ADDENDUM NO. 03

August 14, 2026

Oak Hill United School Corporation – Multi-School MEP Improvements
405 South Washington St, Swayzee, IN 46986
7760 Delphi Pike, Converse, IN 46919
600 Walnut St, Converse, IN 46919

Addendum Three (AD.03) to the drawings and specifications prepared by Gibraltar Design for **Mechanical Improvements Across Three Schools** for Oak Hill United School Corporation Converse, Indiana.

1 UNIT "B" FIRST FLOOR REFLECTED CEILING PLAN

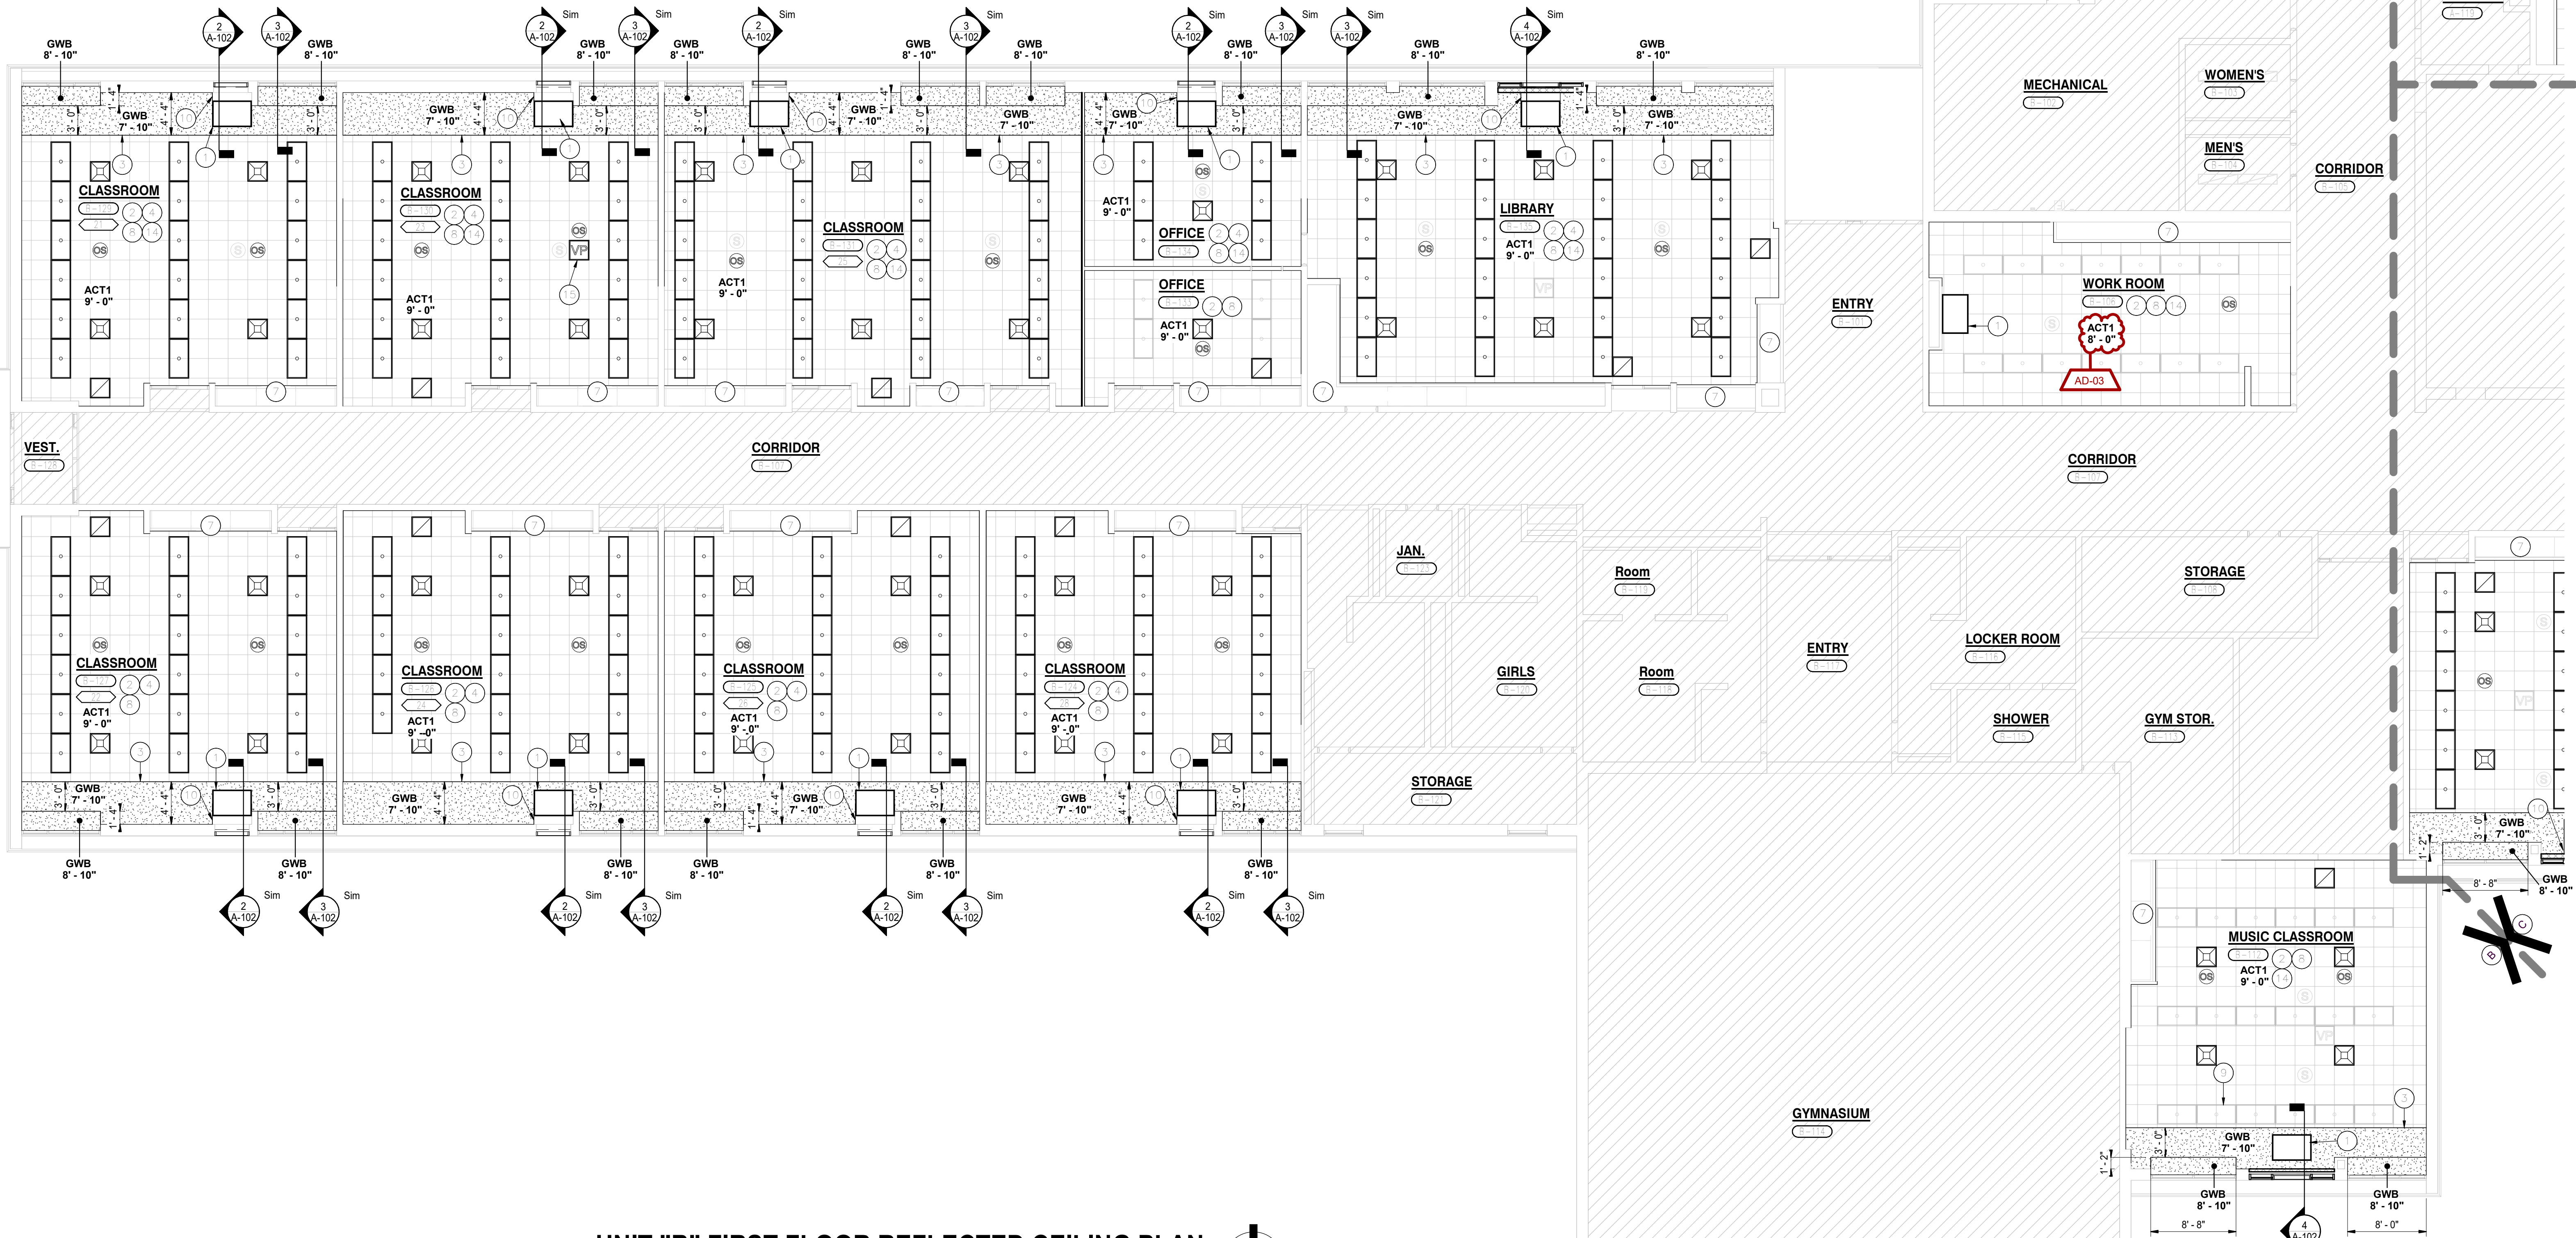
9. Sheet A-902

- A. Refer to revised, full-size drawings, included in this Addendum, for revisions.

1 UNIT "B" FIRST FLOOR MECHANICAL HVAC PLAN
M-102 1/8" = 1'-0"

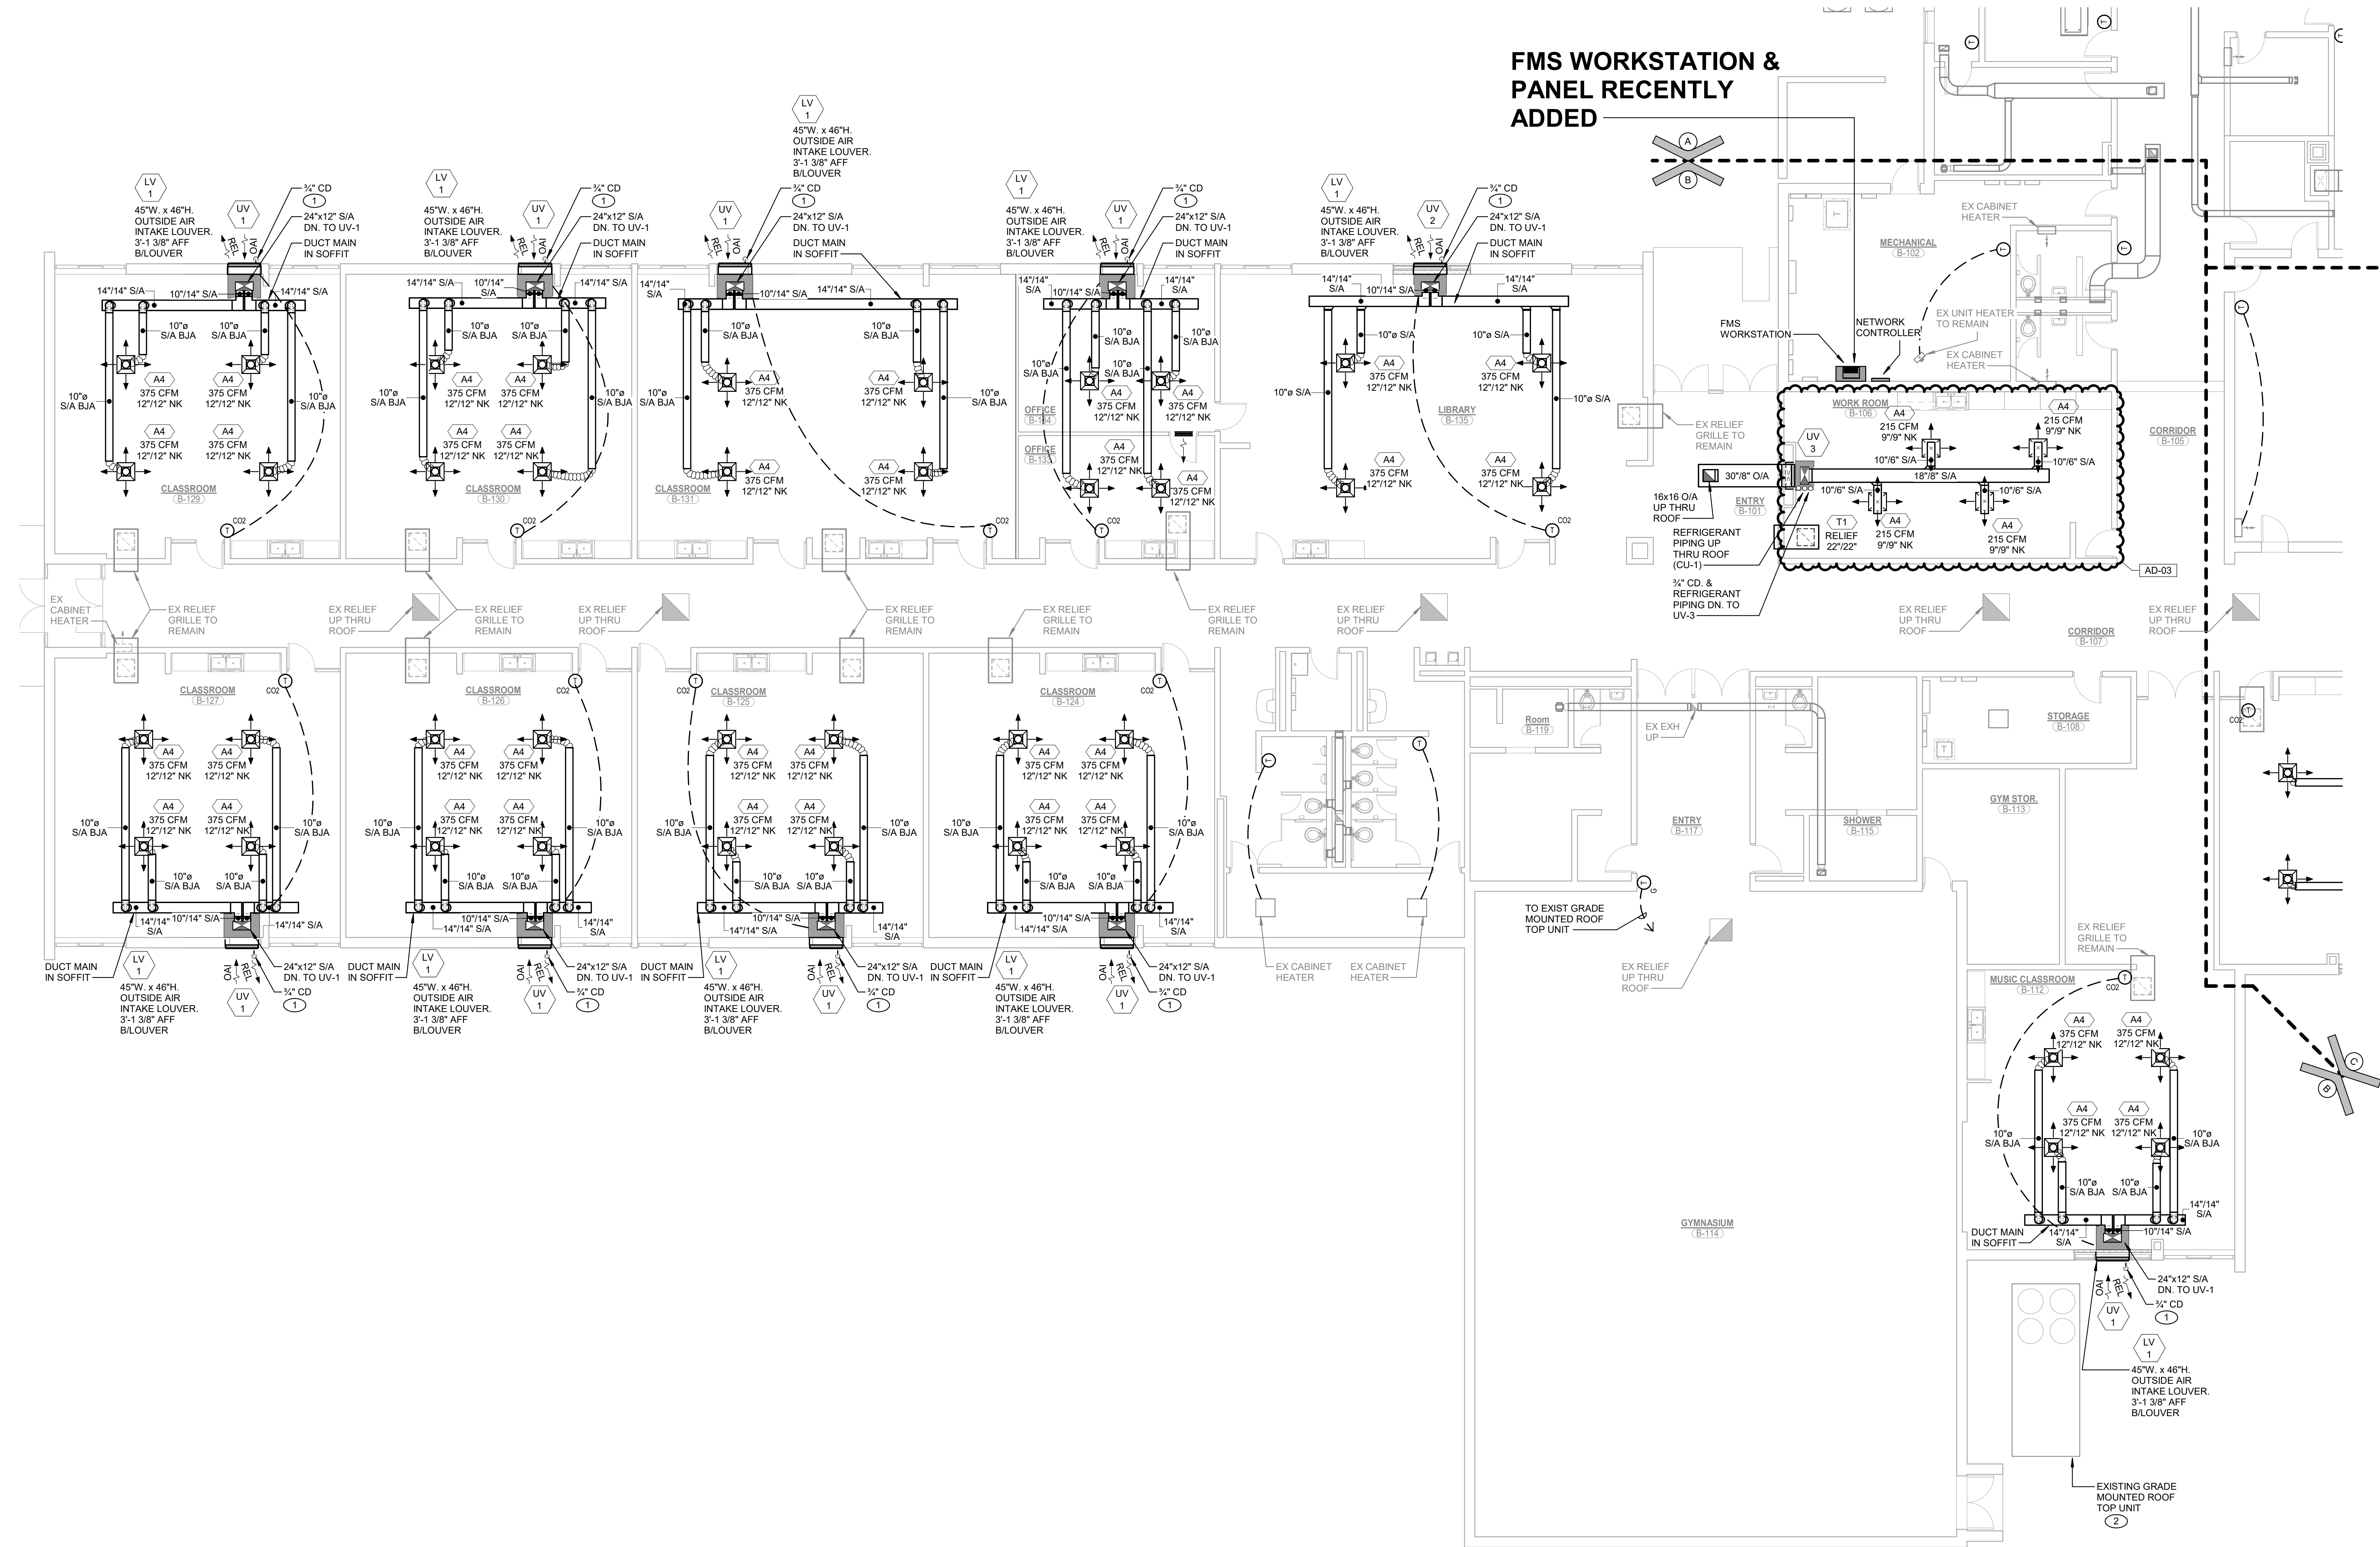
10. Sheet M-102

- A. Refer to revised, full-size drawings, included in this Addendum, for revisions.

1. Revised mechanical ductwork and diffusers in room B-106.

SHEET
B M-102

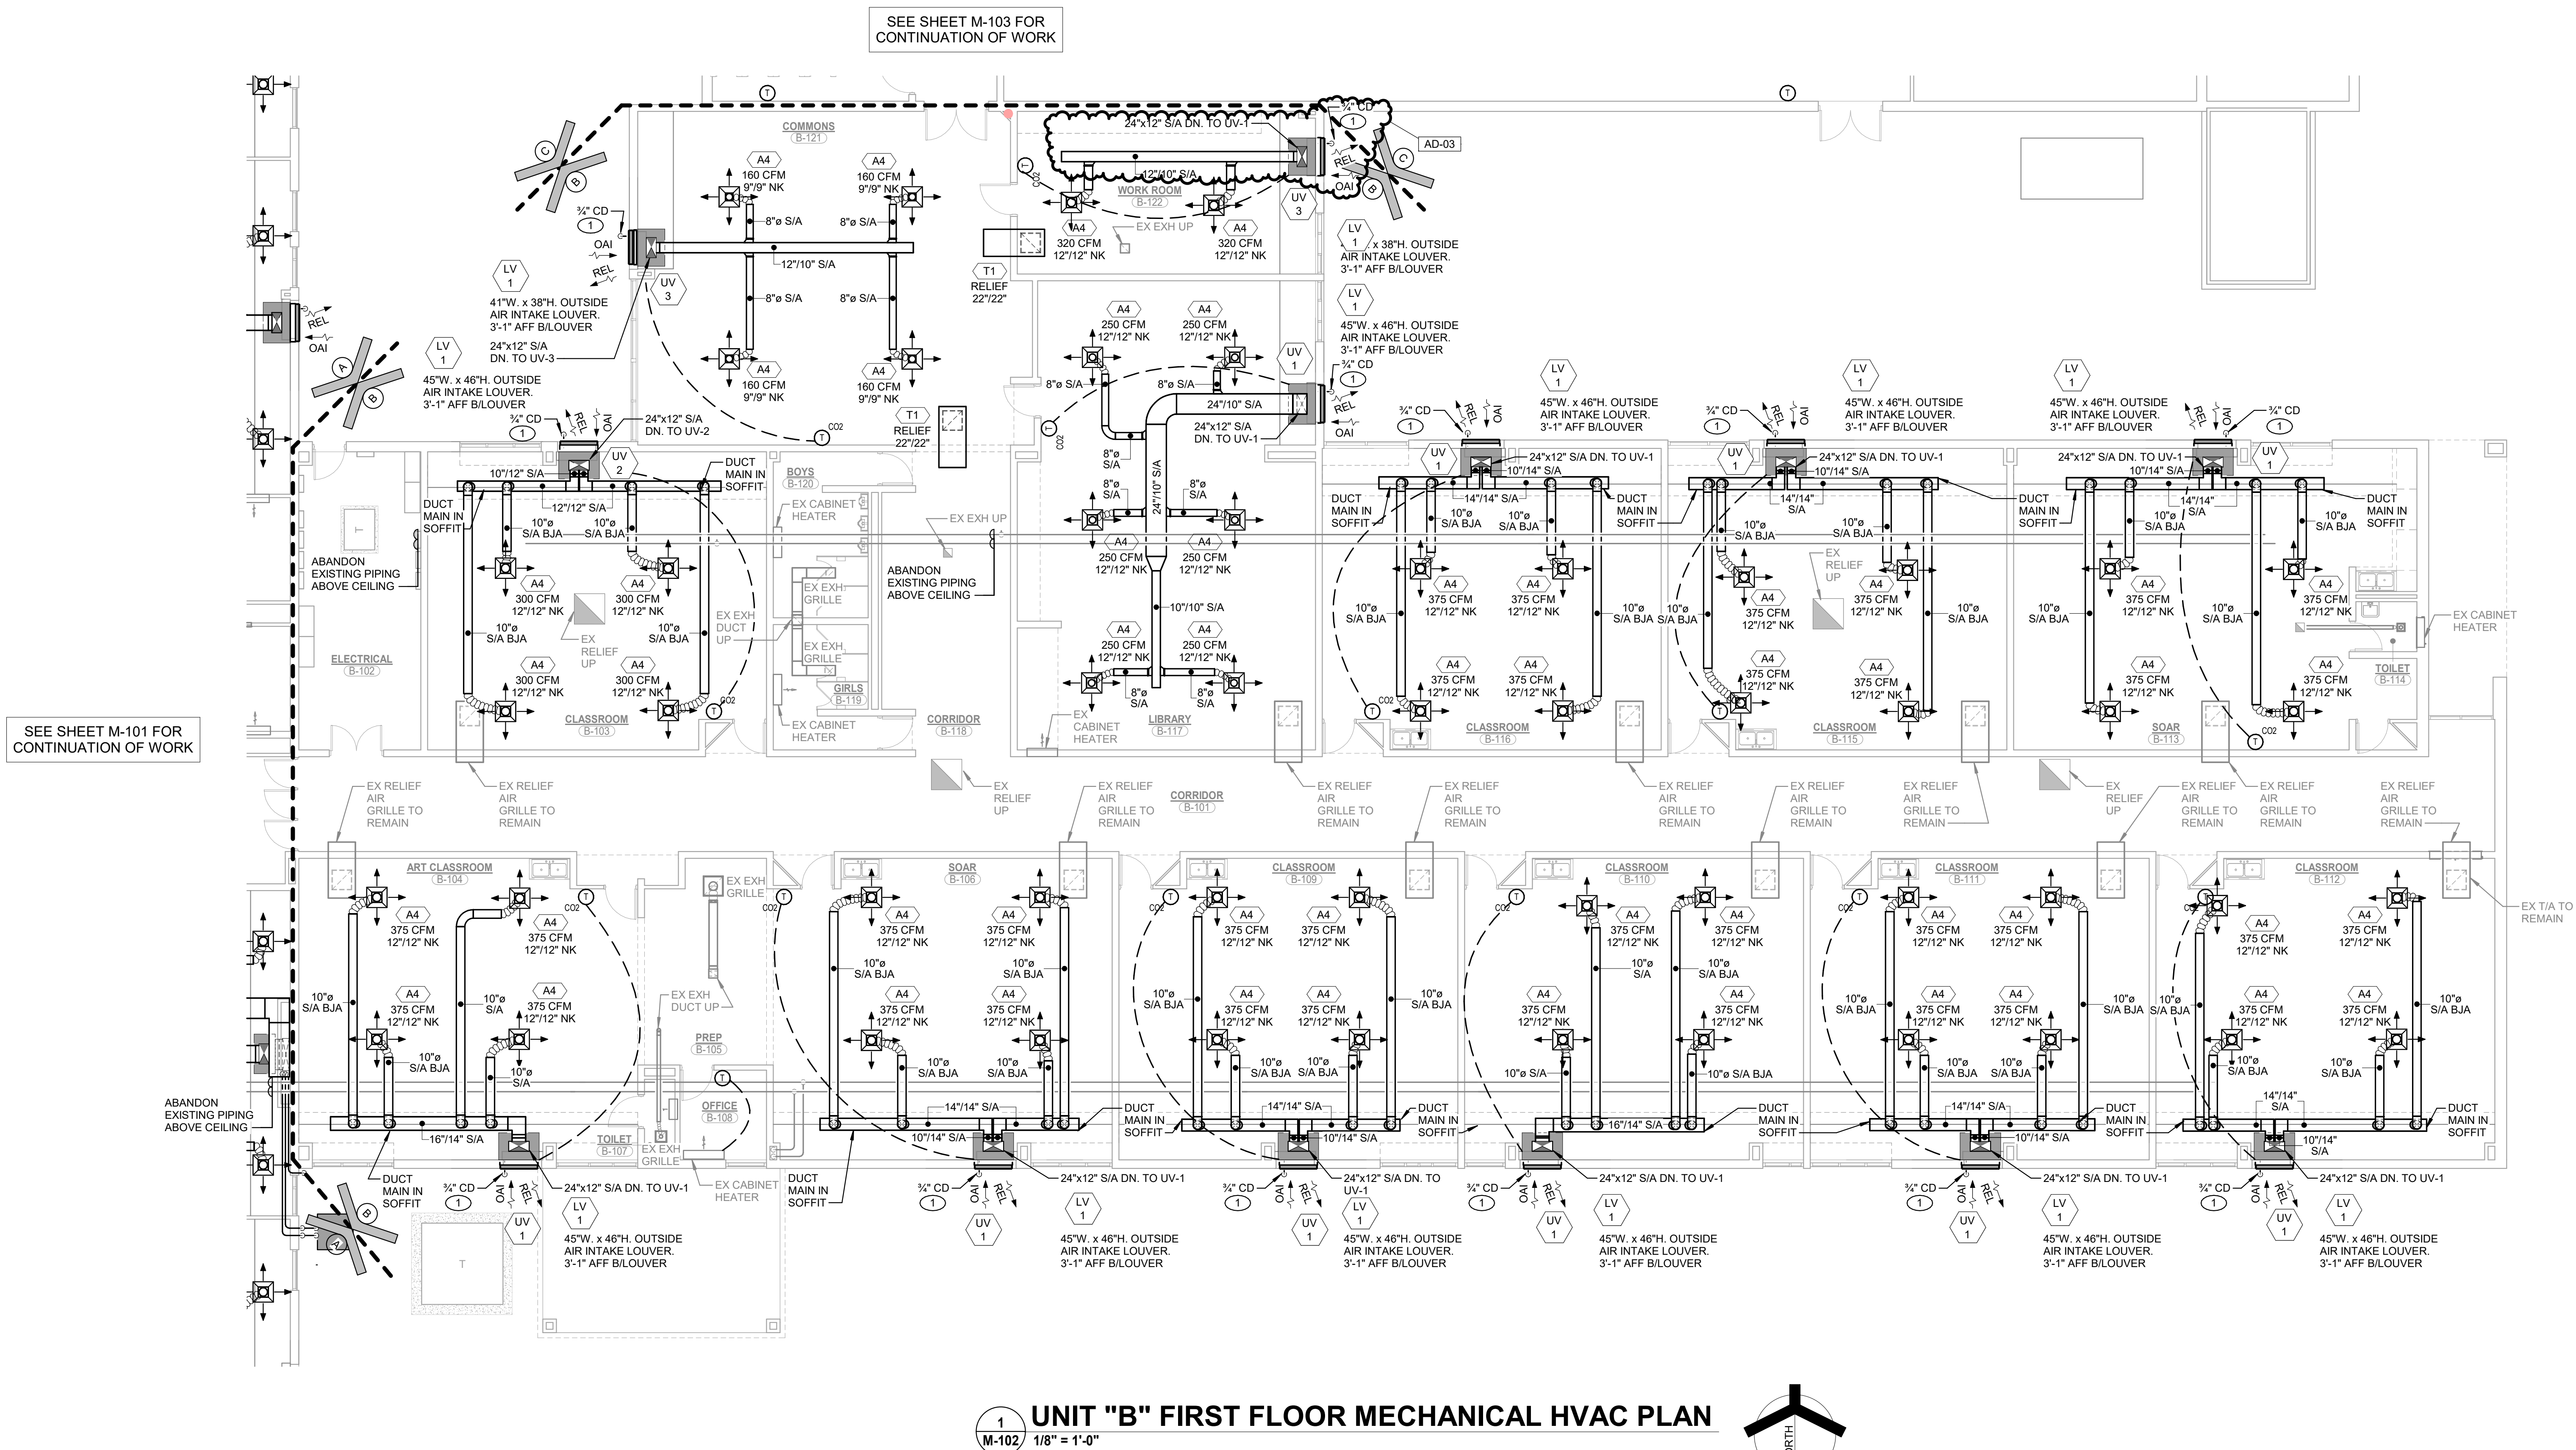
1. Sheet M-102

- A. Refer to revised, full-size drawings, included in this Addendum, for revisions.

1. Modified location of UV-3 to the south.
